Technical Service Bulletin

34 Oil loss via breather line on gearbox

34 18 28 2049944/1 February 7, 2018.

Model(s)	Year	VIN Range	Vehicle-Specific Equipment
R8	2017 - 2018	All	Not Applicable

Figure 4. Panel removal.

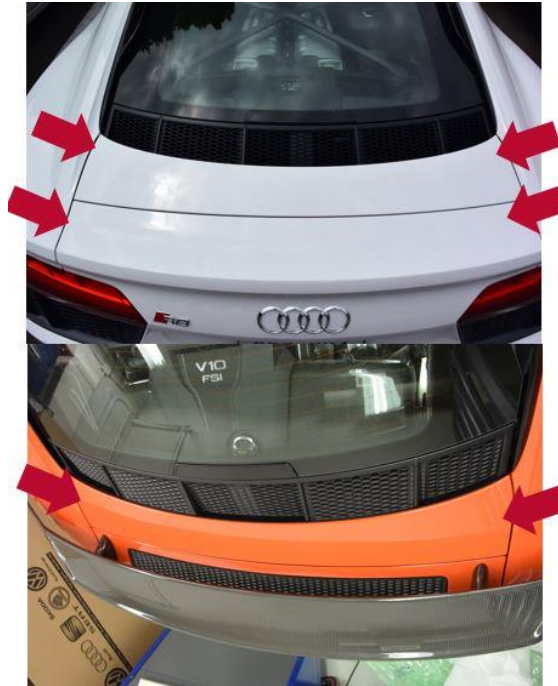
For the R8 V10 the rear retractable spoiler needs to be removed (Figure 4, top).

For the R8 V10 Plus the panel ahead of the fixed spoiler needs to be removed (Figure 4, bottom).

For the R8 Spyder the engine compartment lid must be removed according to the Repair Manual (Figure 5).

Figure 6. Oil tank vent hose.

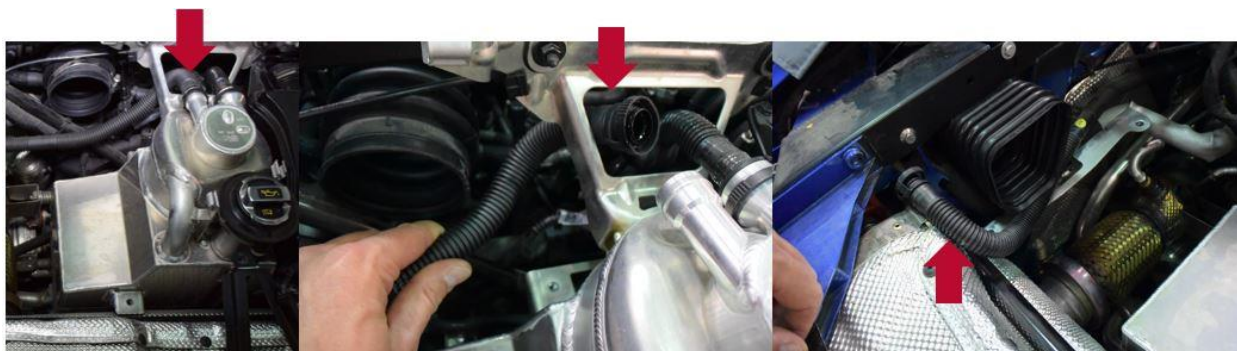
2. Remove the drivers' side vent hose from the engine oil tank. Feed it through the hole in the bracket and tuck it out of the way under the bellows on the drivers' side (Figure 6).

Figure 8. Transmission vent hose connection.

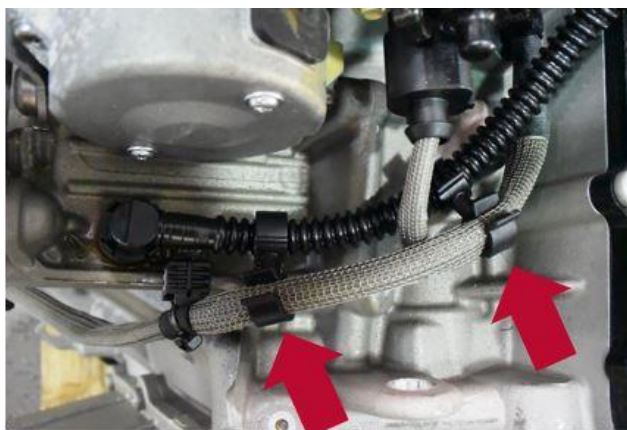
4. There may be a couple of clips securing the wiring harness to the vent hose. Remove the clips from the wiring harness (Figure 8).

Figure 12. Vent hose routing.

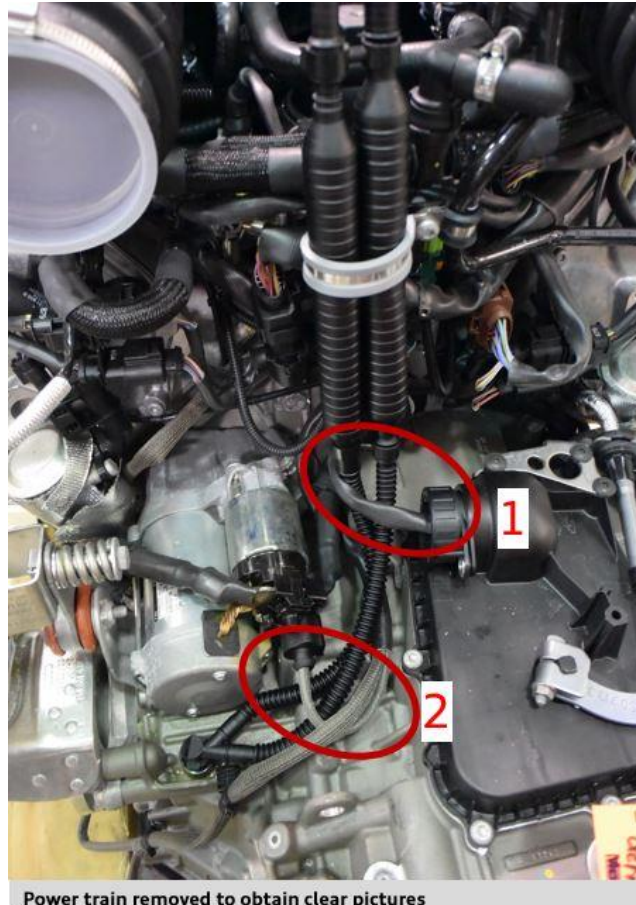
8. Carefully feed the new double vent in to place. The vent hose needs to be installed under the transmission wiring connection and under the starter solenoid wiring connection (Figure 12).

Depending on the car it might be easier to disconnect the wiring connections and reconnect them after installing the vent hose.

Figure 13. Cable tie and anchor clip installation.

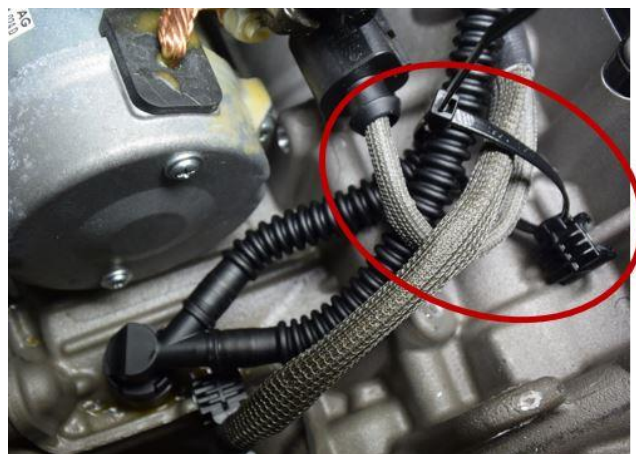
9. Install the supplied cable tie and anchor clip as shown to the rear of the vent hoses with wiring contained in the zip tie. The cable tie does not need to be very tight, just enough to make sure the vent hoses are secure and cannot make contact with the starter motor (Figure 13).
